Appl. No. 10/800,080
Amdt. dated Aug 9, 2005
Reply to Office action June 23, 2005

REMARKS/ARGUMENTS

Annotated Sheet Showing Changes

FIG 2

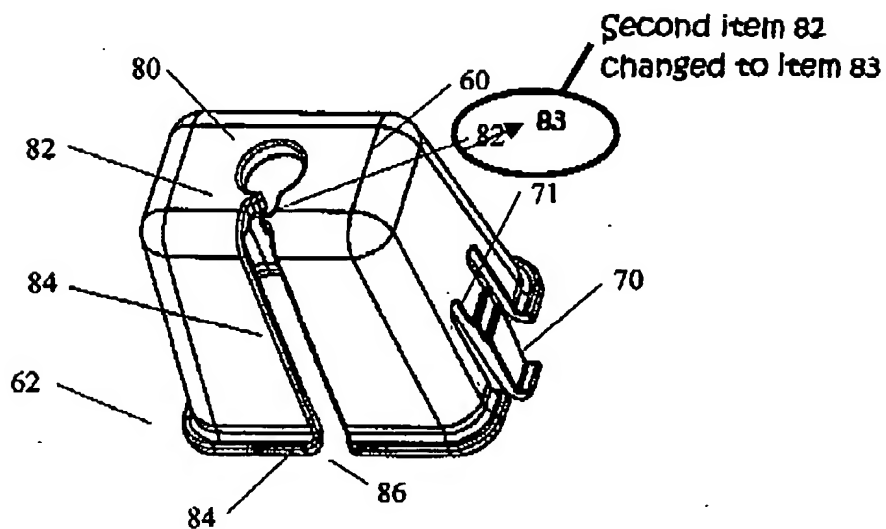
Figure 2 is modified to identify one of the item 82 features as item 83.
